SUBJECT : Hyundai ImageQuest Co., Ltd.
FCC ID: PJIL19A00001
FCC Part 15 Subpart B Certification

Transmitted herewith, on behalf of Hyundai ImageQuest Co., Ltd. is an application for a Class II Permissive Change Certification of the following 19-inch LCD Monitor:

FCC ID : PJIL19A00001
Model/TYPE : L19T/ L19A00000

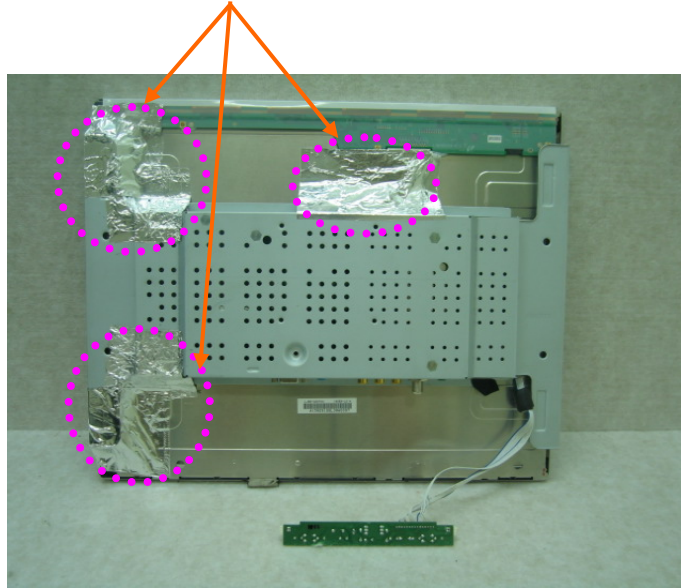
1. Attach aluminum tape on the frame and LCD Rear panel.

2. Apply a ferrite Core to the OSD cable
